CITY OF KIRKLAND

NE 85TH ST PED-BIKE CONNECTION
114TH AVE NE TO 6TH ST
JOB NO. 37-24-PW CIP No. STC1070000

ADDENDUM No. 3 TO THE PLANS, SPECIFICATIONS, PROPOSAL AND CONTRACT

Issued This Date: Friday, January 31, 2025
Bid Opening: **Unchanged – February 5, 2025**
Place of Opening: City Hall, Council Chambers

DWG. NO. RP3

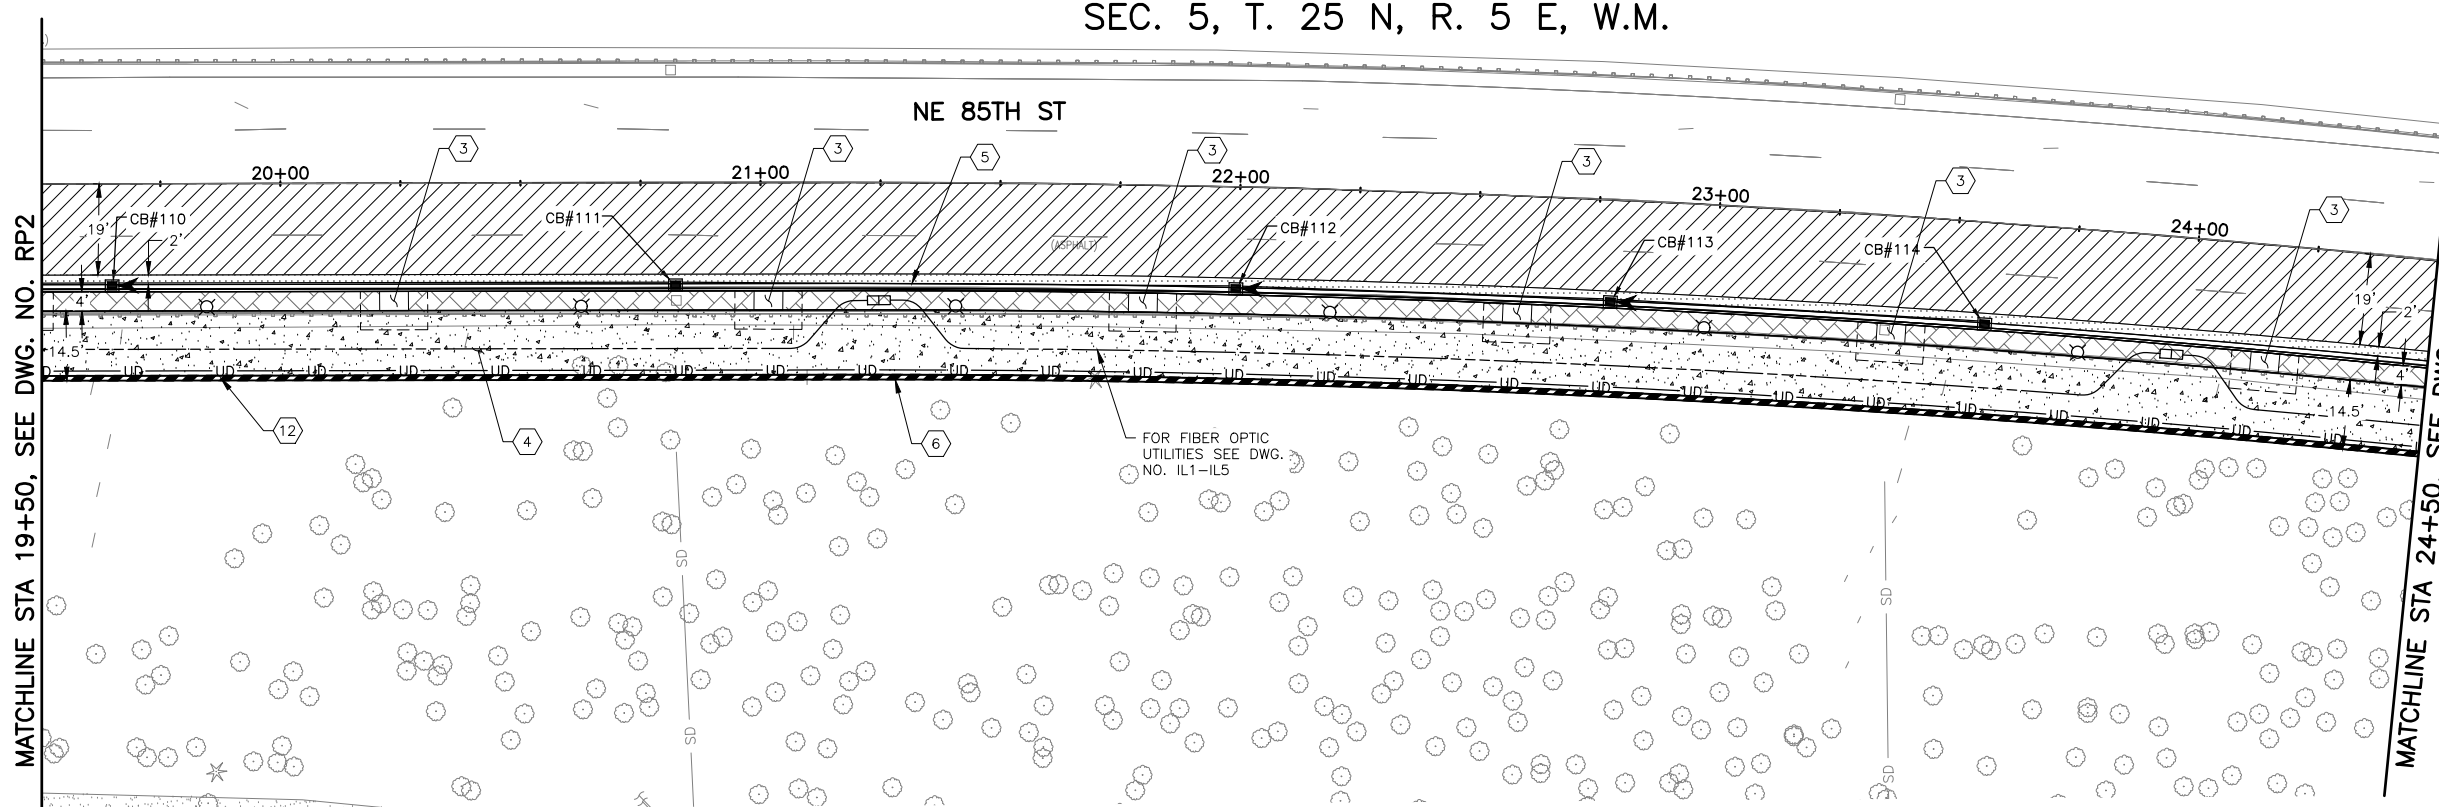
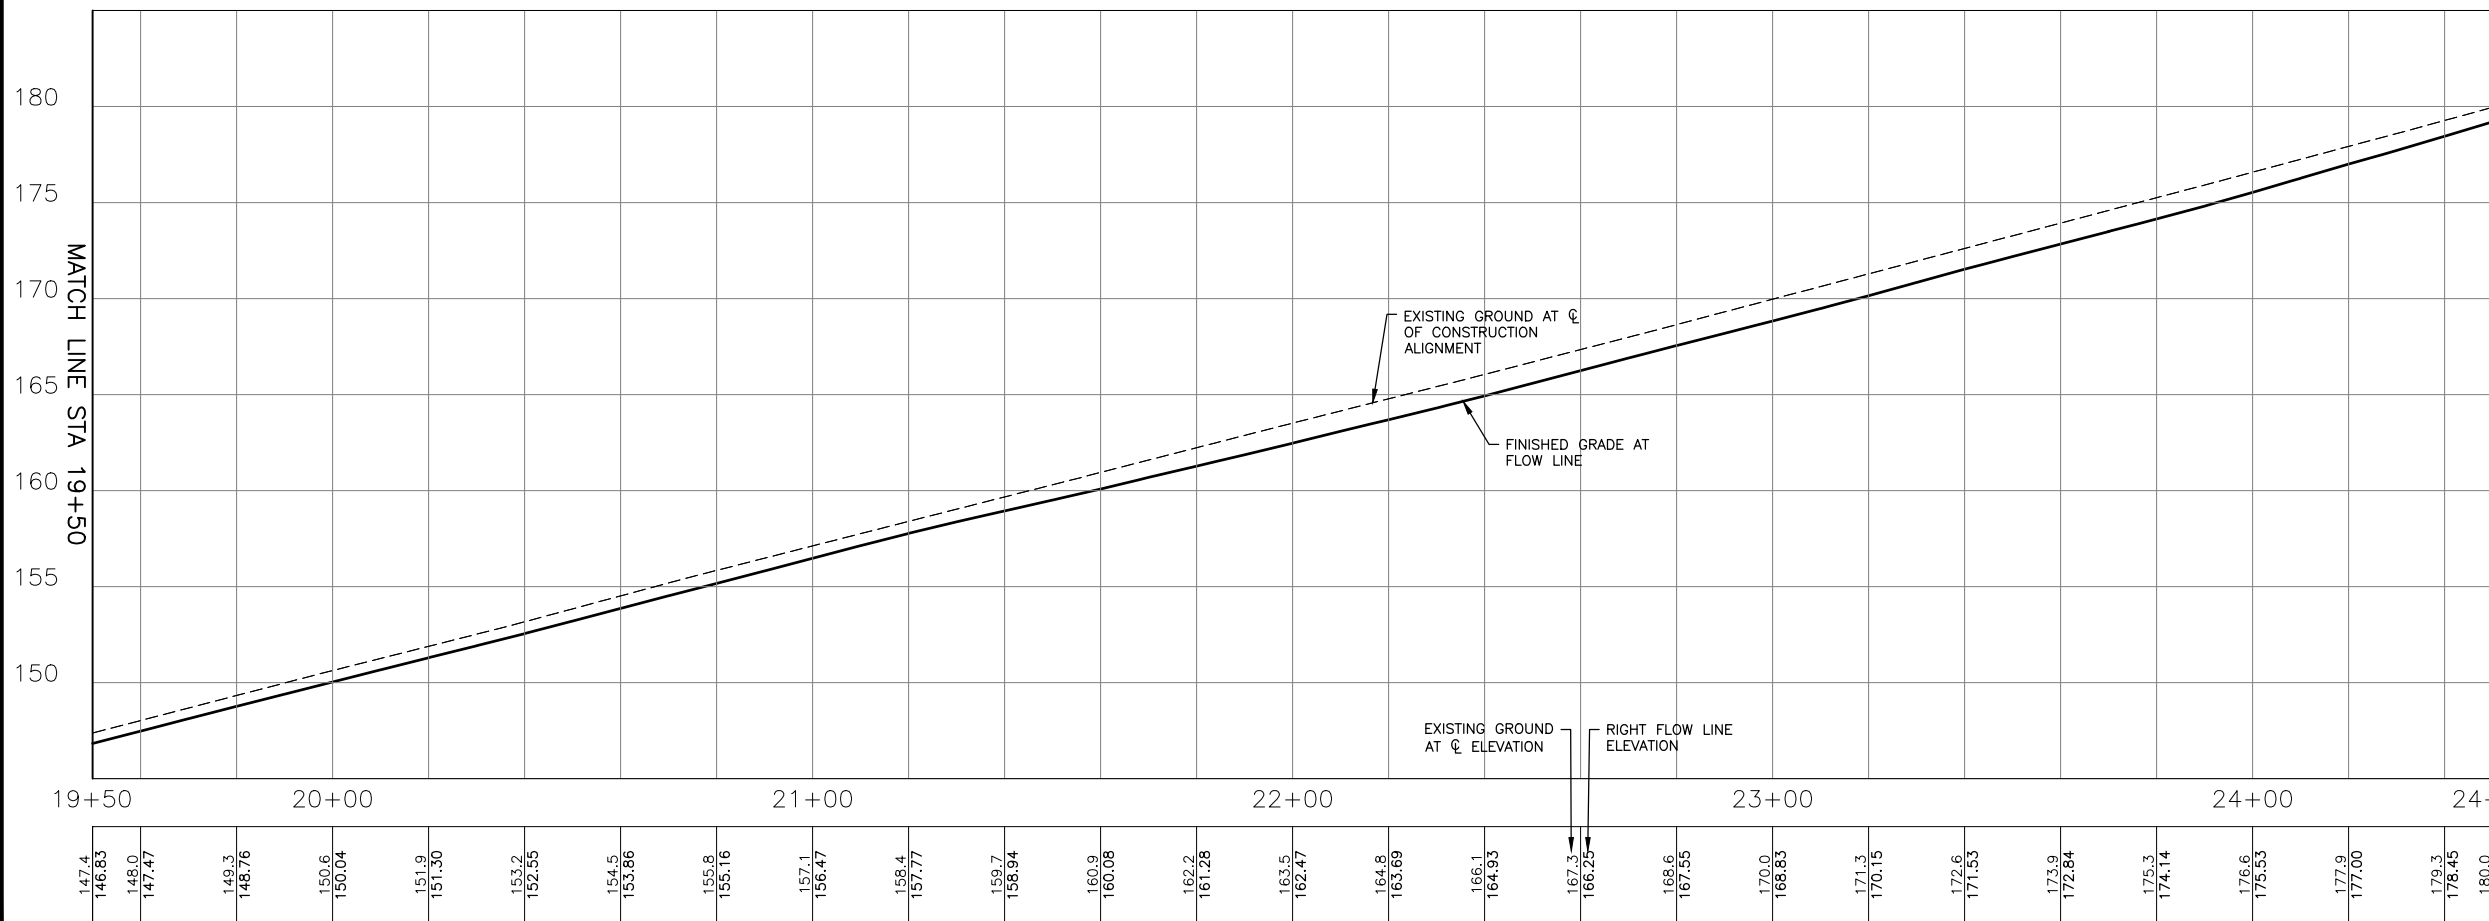
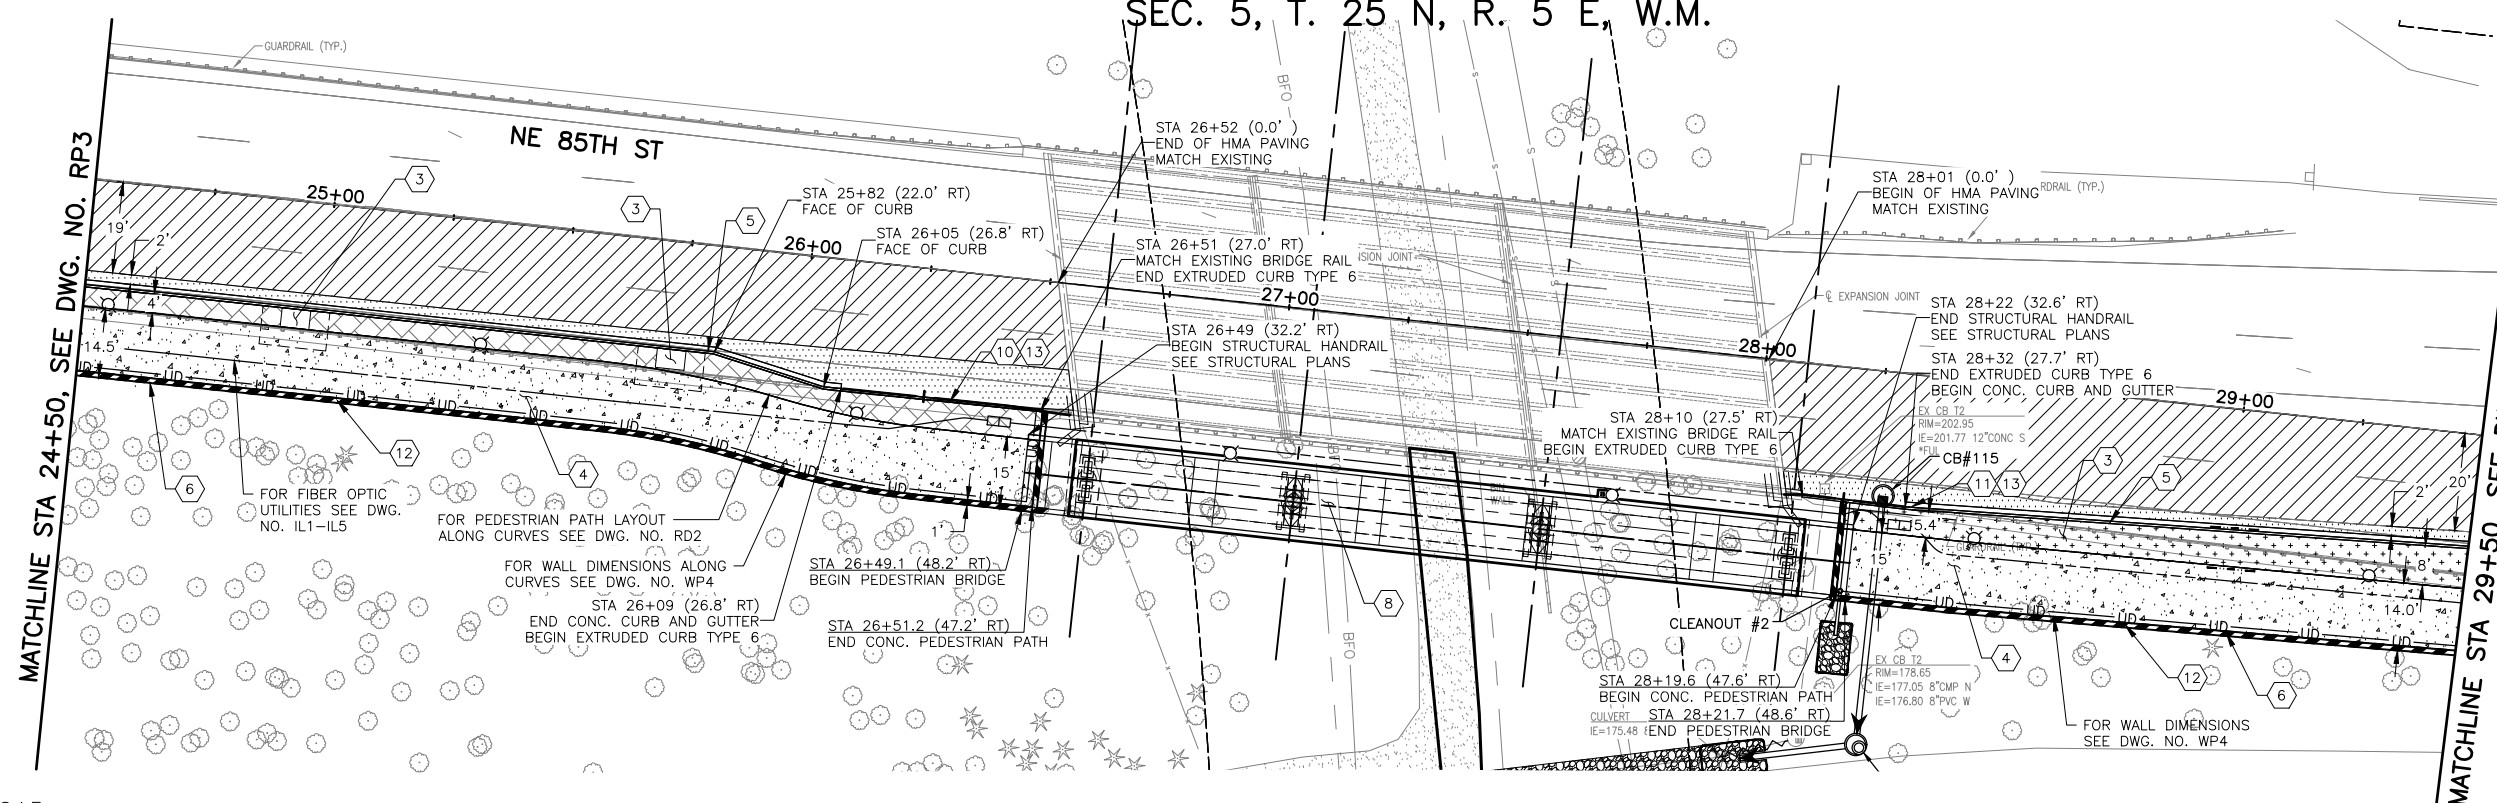
FILE	ENGR.	REVIEW	SCALE	DATE
RP3	##	##	AS SHOWN	JANUARY 2025
Δ	STAMPED CONC. DEPTH UPDATE	VWW	VWW	1/31/2025
NO.	REVISION	BY	REVIEW	DATE

DWG. NO. RP4

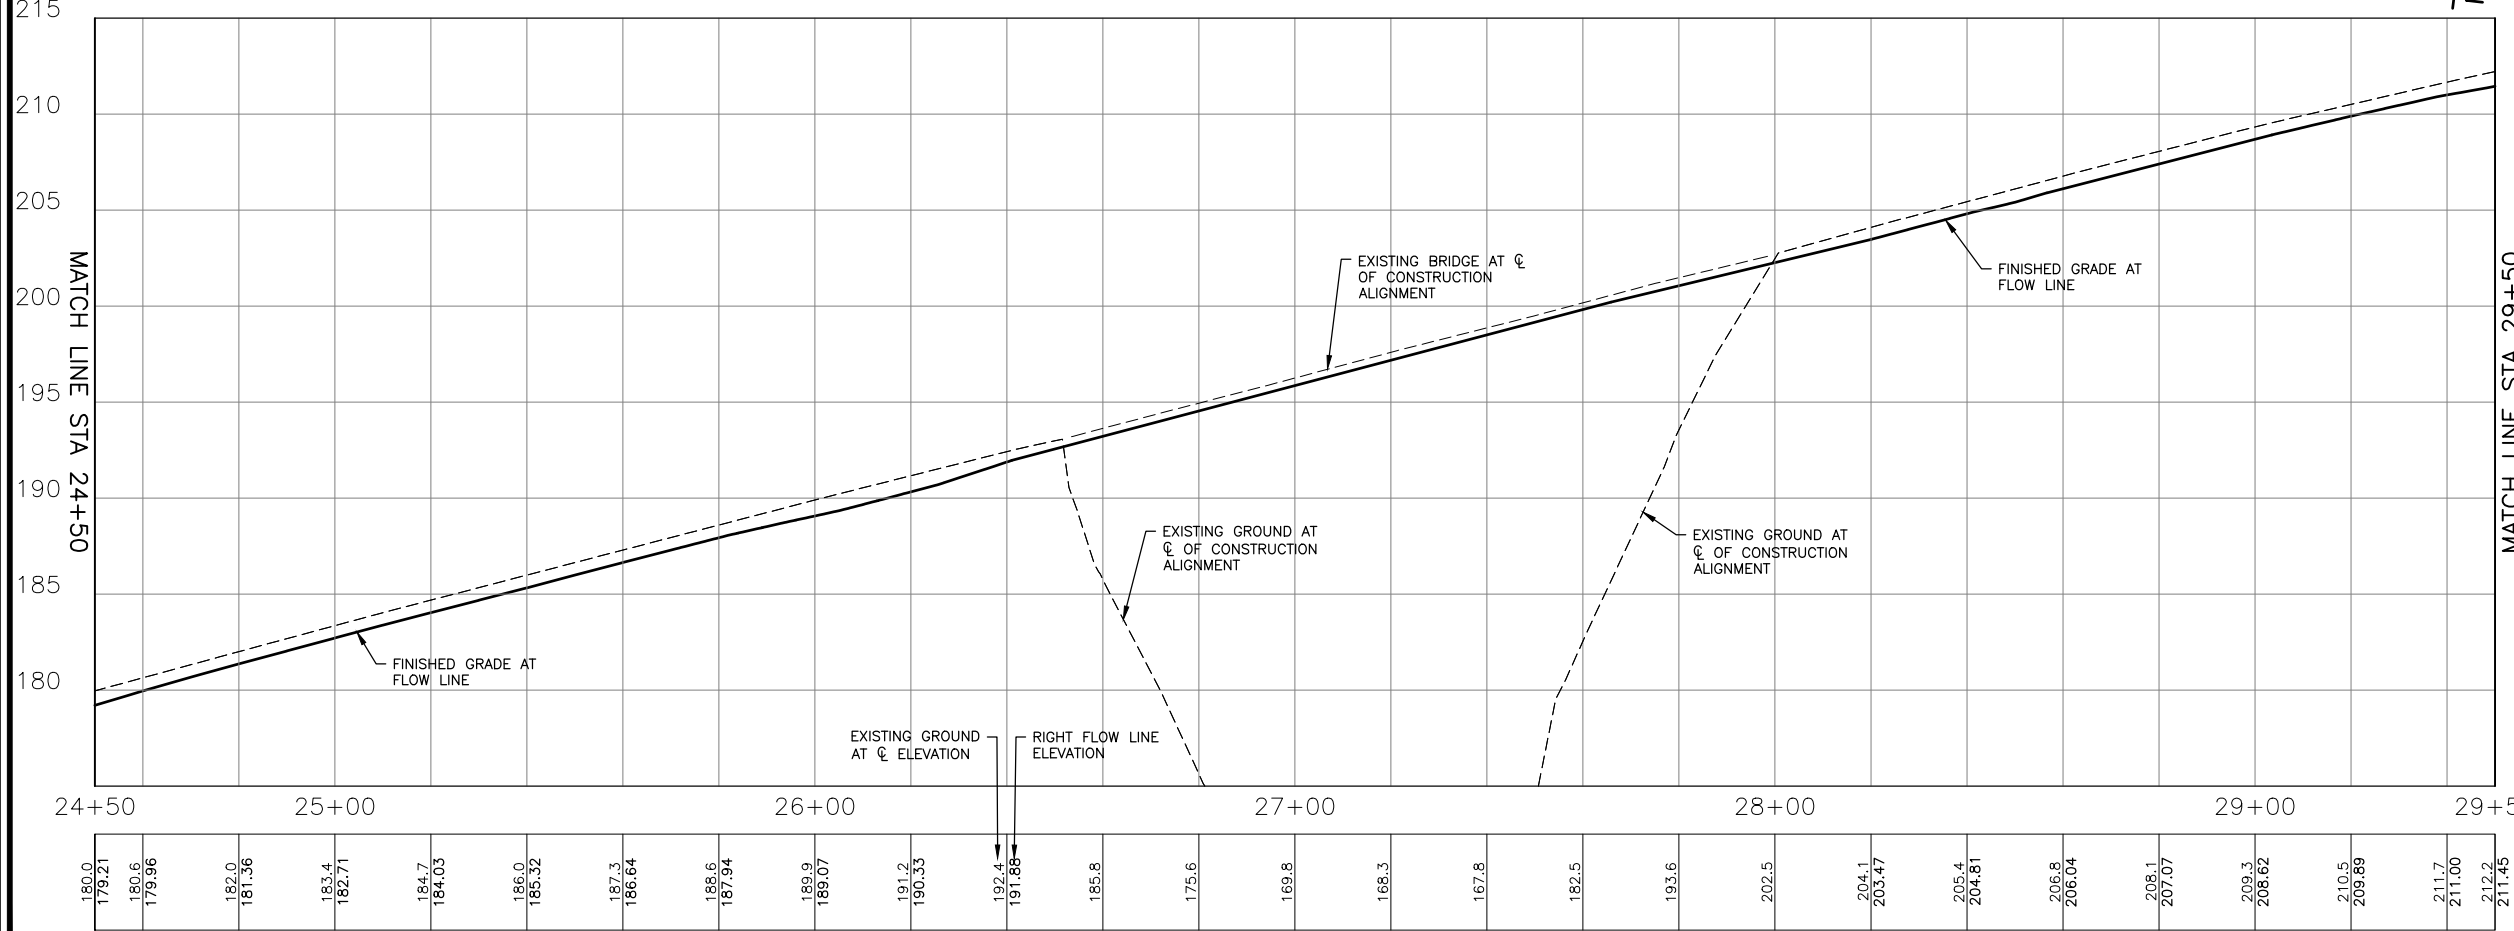
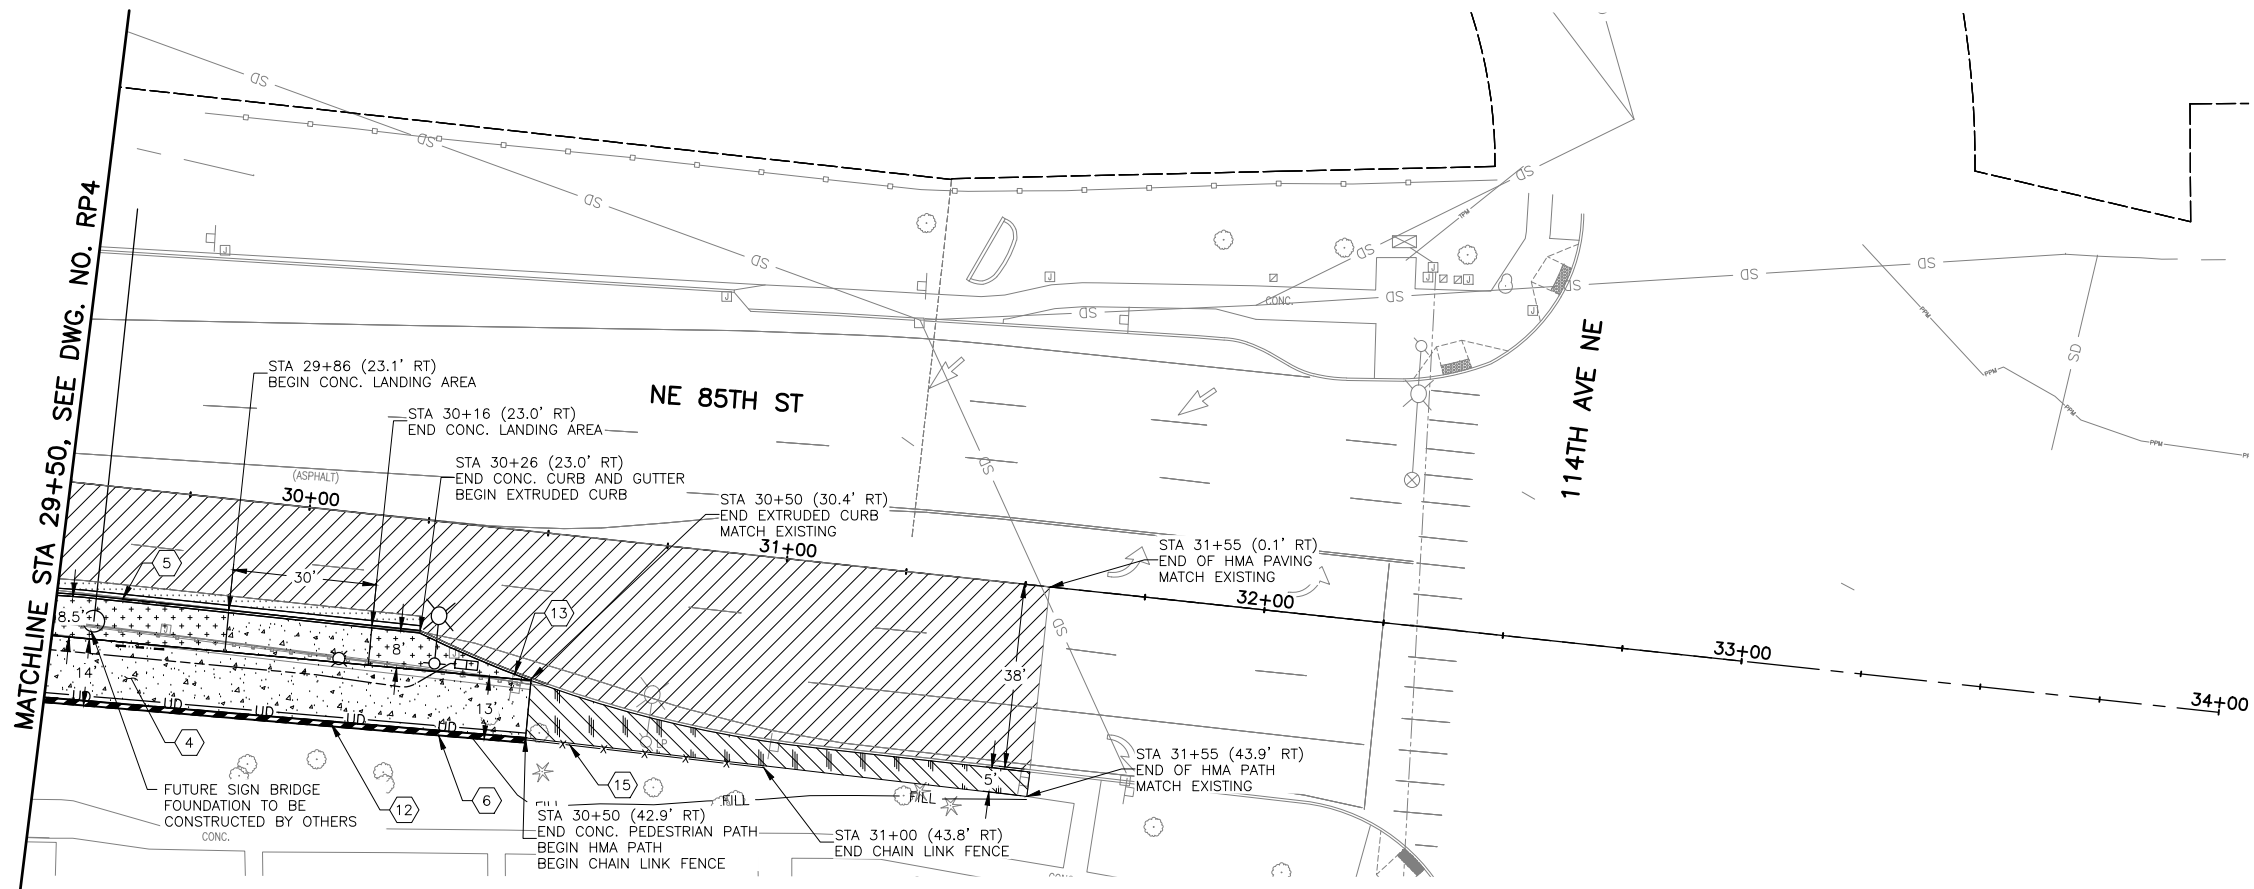
FILE	ENGR.	REVIEW	SCALE	DATE
RP4	##	##	AS SHOWN	JANUARY 2025
Δ	STAMPED CONC. DEPTH UPDATE	VWW	VWW	1/31/2025
NO.	REVISION	BY	REVIEW	DATE
